# UNITED STATES PATENT AND TRADEMARK OFFICE

APPLICATION NO.	FILING DATE	FIRST NAMED INVENTOR	ATTORNEY DOCKET NO.	CONFIRMATION NO.
10/648,423	08/25/2003	Edward Kirko	KIE-0002	3997
7590 02/14/2006 CANTOR COLBURN LLP 55 Griffin Road South Bloomfield, CT 06002			EXAMINER MEISLIN, DEBRA S	
			ART UNIT	PAPER NUMBER
			3723

<b>Office Action Summary</b>	<b>Application No.</b> 10/648,423	<b>Applicant(s)</b> KIRKO, EDWARD	
	<b>Examiner</b> Debra S. Meislin	<b>Art Unit</b> 3723

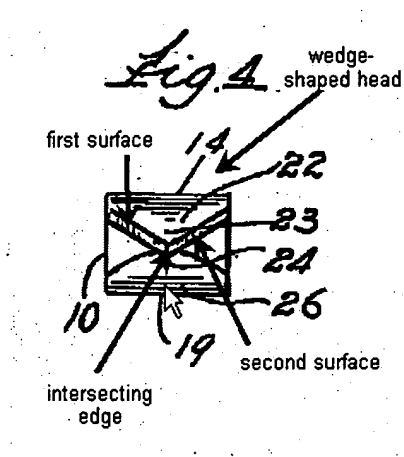
Kaskouras discloses a wedge-shaped head having a first surface, a second surface, and an intersecting edge defined by the first and second surfaces (see figure 4), below:

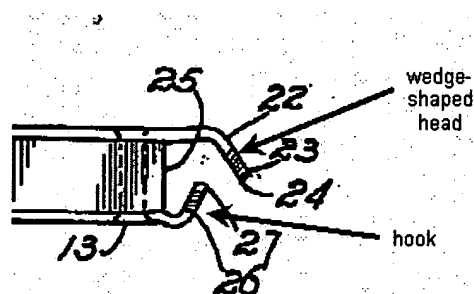
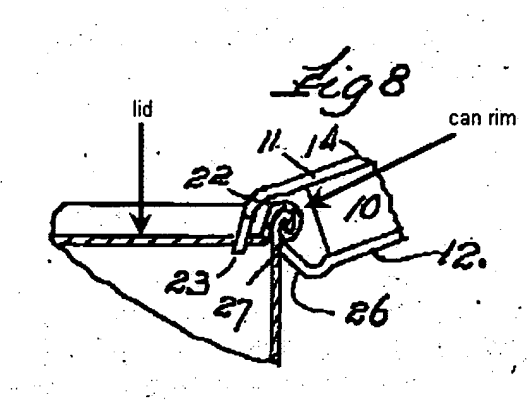
Kaskouras discloses a hook extending from the length of rigid material proximate to the wedge-shaped head, the hook being configured to engage a portion of a rim of a flip-top can such that when the flip-top can opener is pivoted about the portion of the rim, the intersecting edge engages a lid of the can in a manner that substantially removes a portion of the lid of the can disposed between an opening and the rim, wherein a fluid in the can flows through an enlarged opening of the can as shown in figures 2 and 8, below:

A recitation of the intended use of the claimed invention must result in a structural difference between the claimed invention and the prior art in order to patentably distinguish the claimed invention from the prior art. If the prior art structure is capable of performing the intended use, then it meets the claim. Note that the hook of Kaskouras is capable of engaging a "flip-top" can.
